REVIEW OF EMERGENCY RESPONSE
CONSIDERATIONS FOR THE VALLEY
CENTER ROAD CORRIDOR CONCEPT
PLAN DESIGN OPTIONS

FINAL REPORT

SAN DIEGO COUNTY

SUPPLEMENT TO THE SEPTEMBER 2023 REVIEW OF
EMERGENCY RESPONSE CONSIDERATIONS FOR THE VALLEY
CENTER ROAD CORRIDOR CONCEPT PLAN DESIGN OPTIONS:
ADDRESSING THE DRAFT FINAL CORRIDOR CONCEPT PLAN

Exhibit 1 - Draft CCP Option A

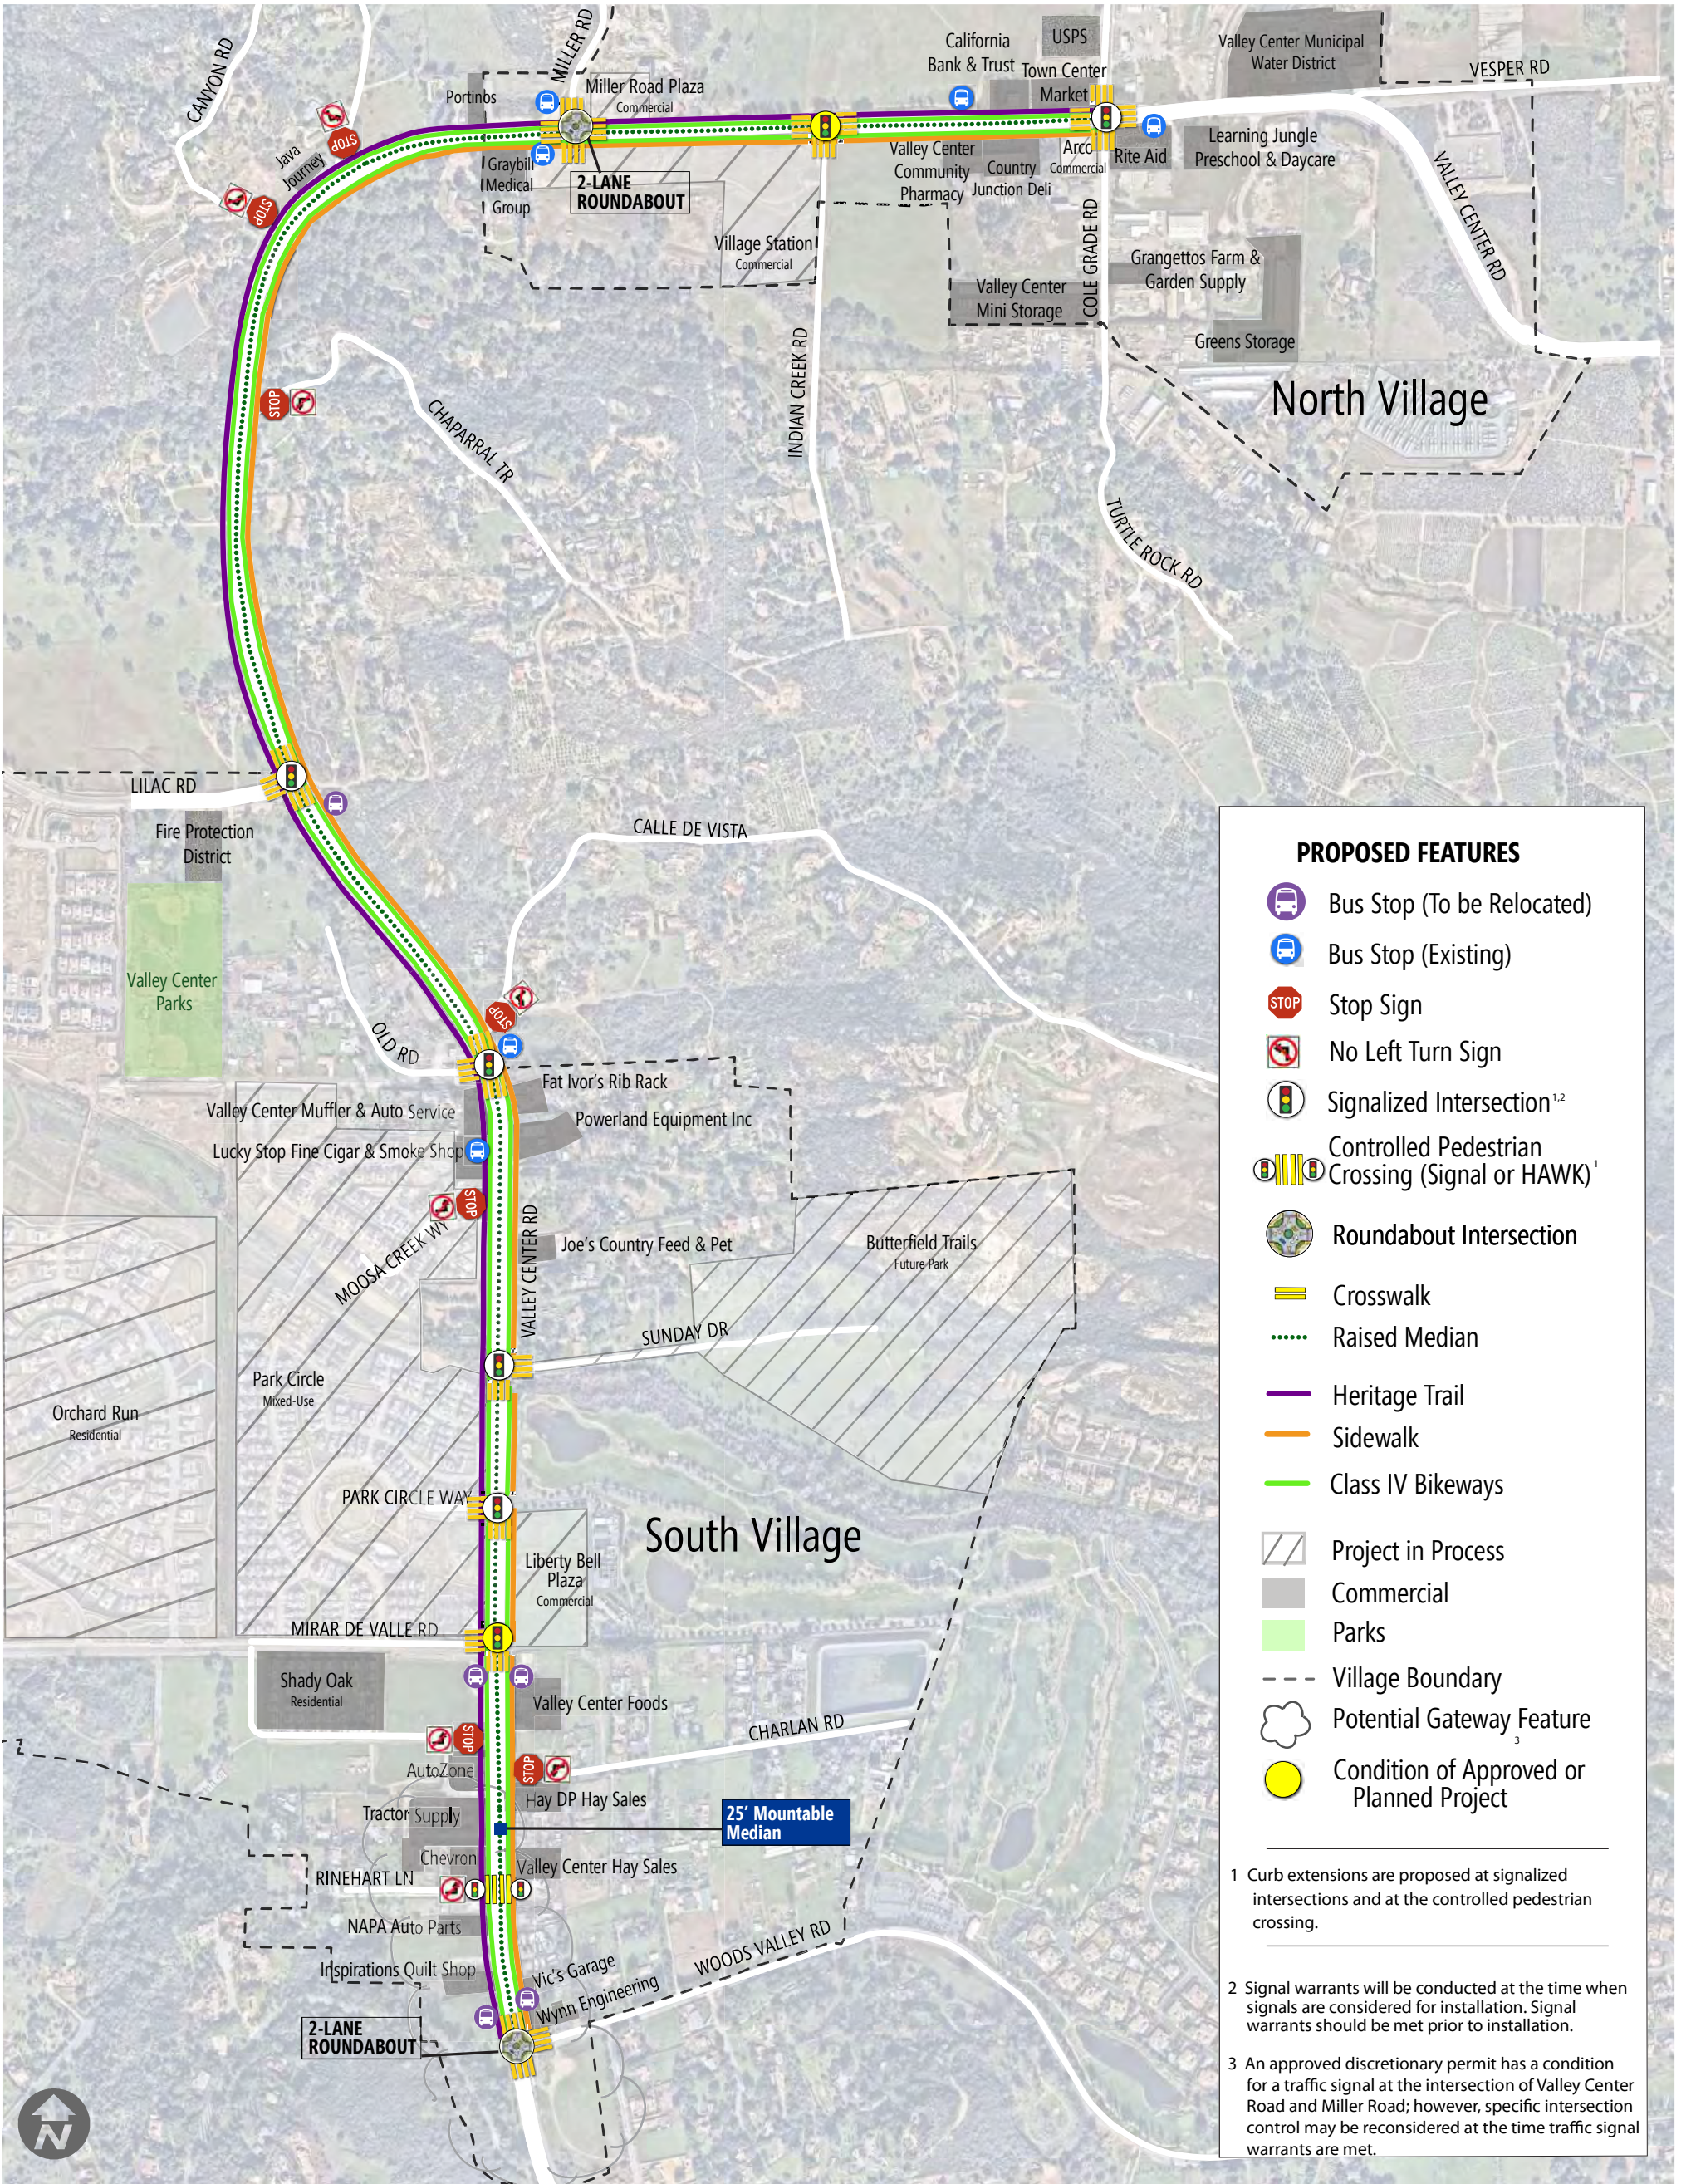
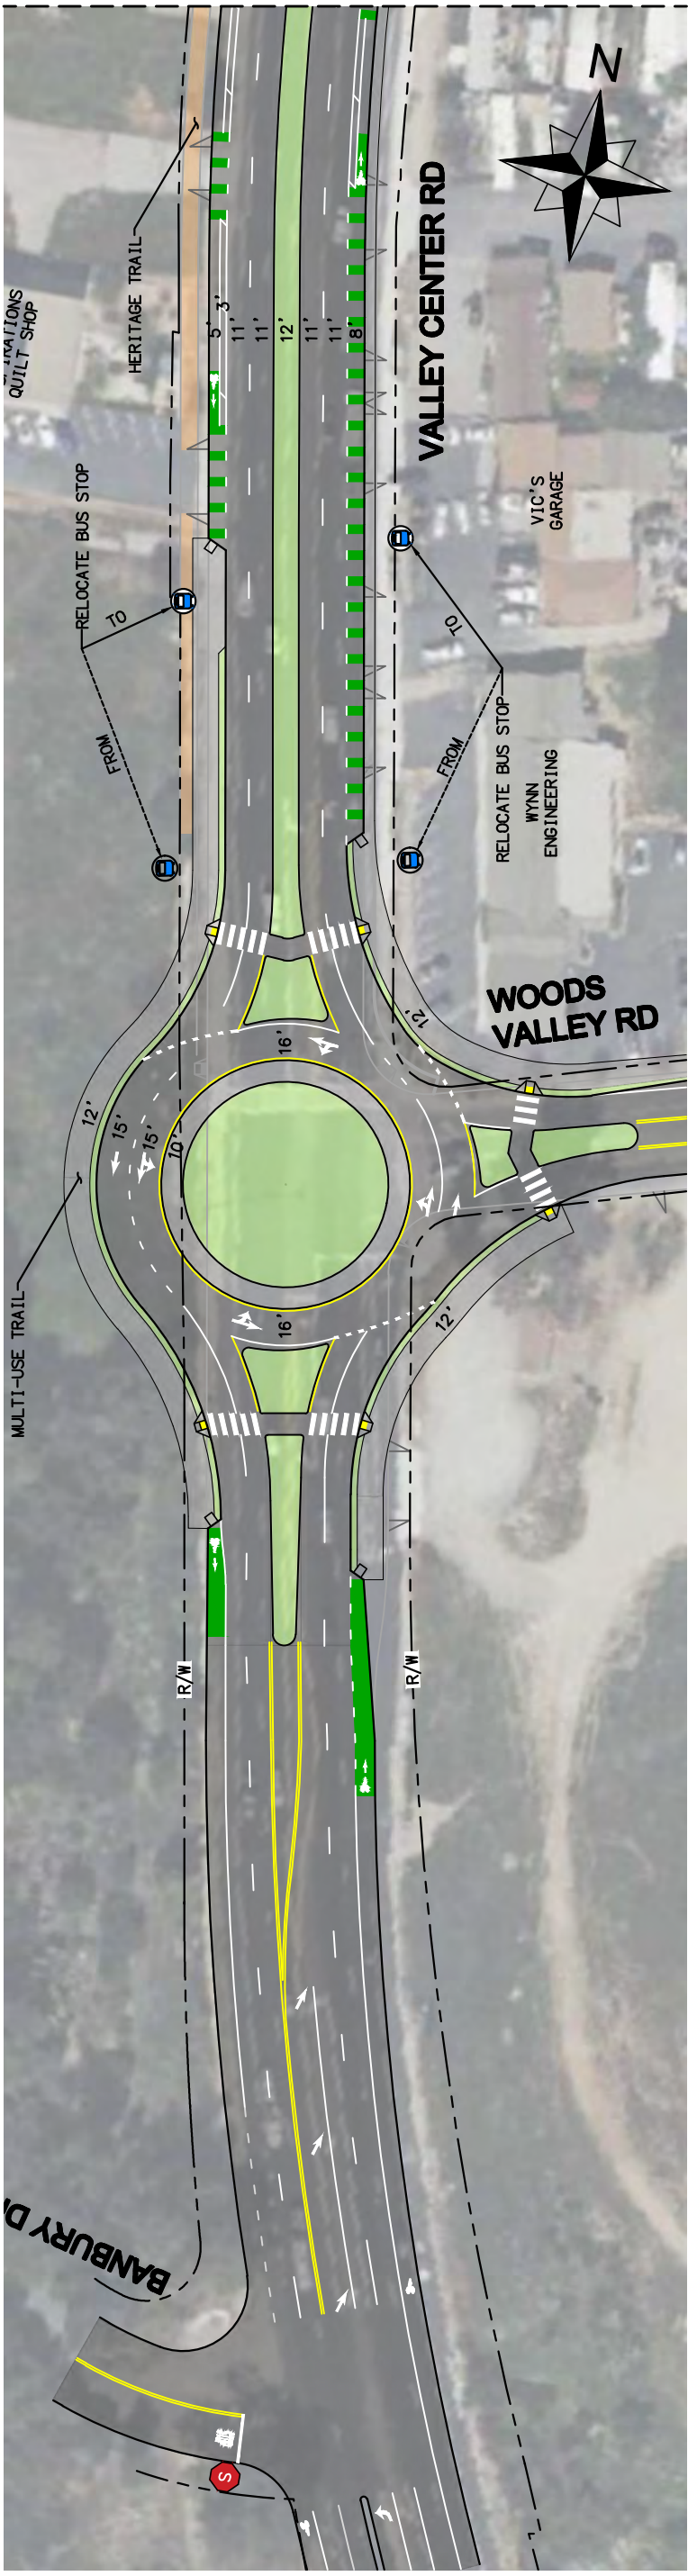
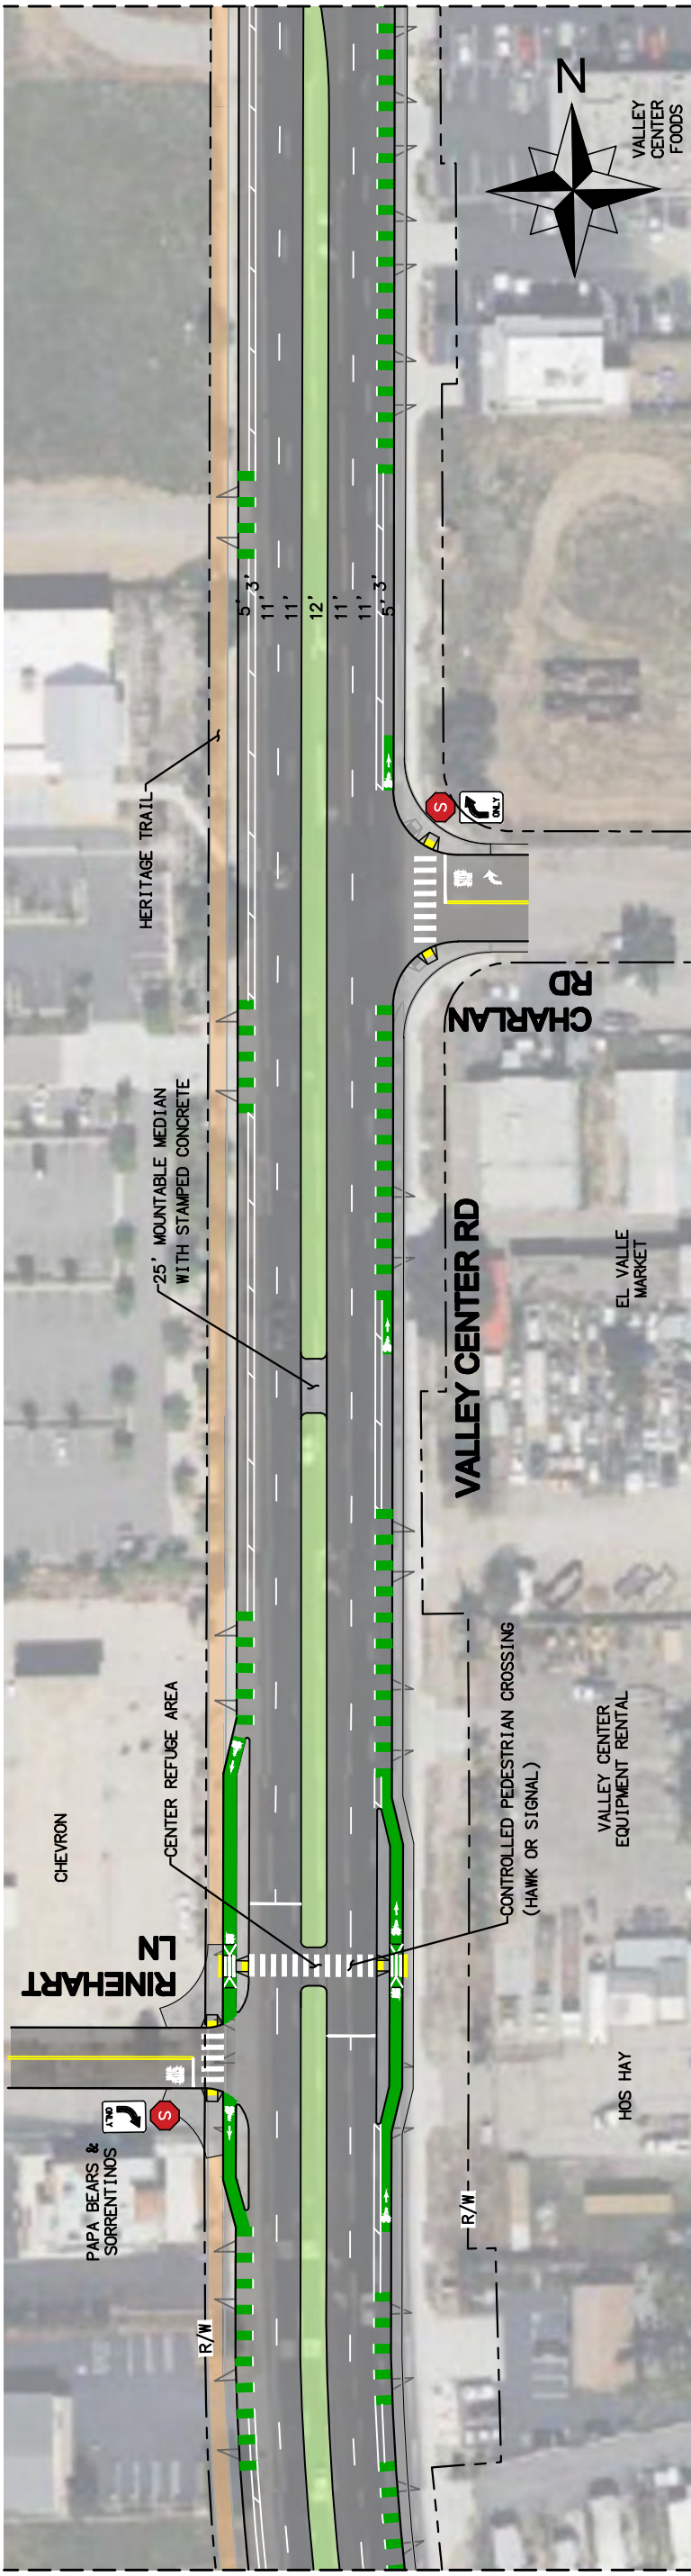
As of June 2023, the County was considering new options for traffic signals and roundabouts in addition to addressing other CCP components for road user safety. Both Option A and Option B—Exhibits 1 and 2 to this report—include the use of seven traffic signals (including two associated with private development requirements and two newly proposed), one pedestrian signal, and two

dual-lane roundabouts. Both options feature roundabouts at Woods Valley Road. Option A has a roundabout at Miller Road and a signal at Cole Grade Road. Option B has a signal at Miller Road and a roundabout at Cole Grade Road.

Citygate observes that, northbound from the fire station on Lilac Road to Cole Grade Road, Option A, with a single roundabout in addition to the other proposed safety controls, is 0:24 seconds slower. Option B is 0:36 seconds slower. A “no roundabout” option is 1:00 minute slower.
